Fairmont Resort Port Douglas Response to Information Request

March 2021

Figure 2-1 Street view analysis

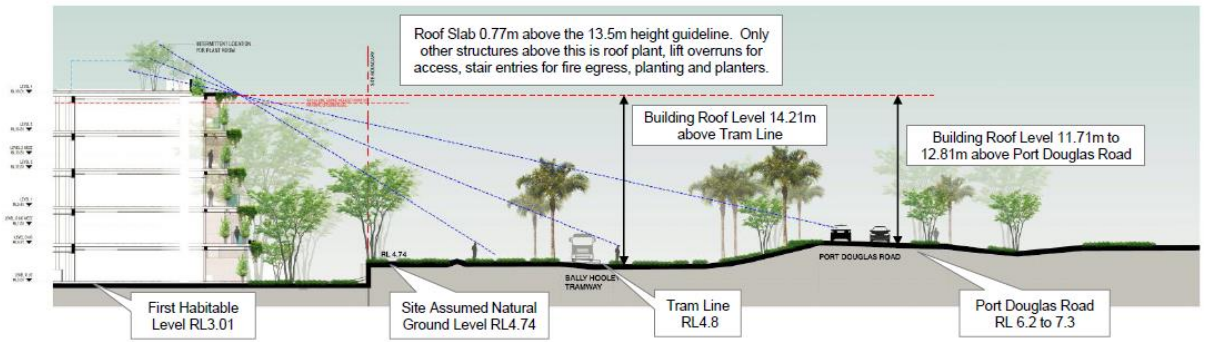
1. *The proposed building height is approximately 20 metres with Council's Planning Scheme limiting building height to 13.5 metres. The proposal to exceed the prescribed height limit conflicts with the performance outcomes and purpose of the Tourist Accommodation Zone Code. In addition, it conflicts with Theme 4, 3.7.1 (2) of the Strategic Framework. Demonstrate how the proposed height breach can comply with the purpose of the zone code and the Strategic Framework and confirm the height of the building in accordance with the definition of building height from the 2018 Douglas Shire Planning Scheme version 1.0.*

Based on the natural ground level of 4.74 m, the roof level of the proposed development at the front of the street boundary is 0.77 m above the 13.5 m height limited stipulated in the Planning Scheme. The Applicant believes that the reference point Council has used for assessing the height of the building, being the lowest habitable level of 3.01 m, is not consistent with other local governments throughout Queensland (and Australia) where the measurement of height is from the nominated natural ground level.

The Applicant believes that given the lowest habitable level of the proposed resort is an excavated level, the real intent of the PO1 and AO1.1 of the Planning Scheme is to limit developments to 13.5 m above natural ground level, and therefore the height of the building should be assessed from the natural ground level of 4.74 m. Chido believe that the proposed tropical design along with the extensive landscaping and use of modern architectural features reduces the bulk of the building to reduce visual impacts.

The Applicant would also like to note that the development is 1.46 m to 2.56 m below Port Douglas Road, thereby reducing the visual impact of the resort and the impact of the 0.77 m above the height limit is further diminished. Figure 2-1 refers.
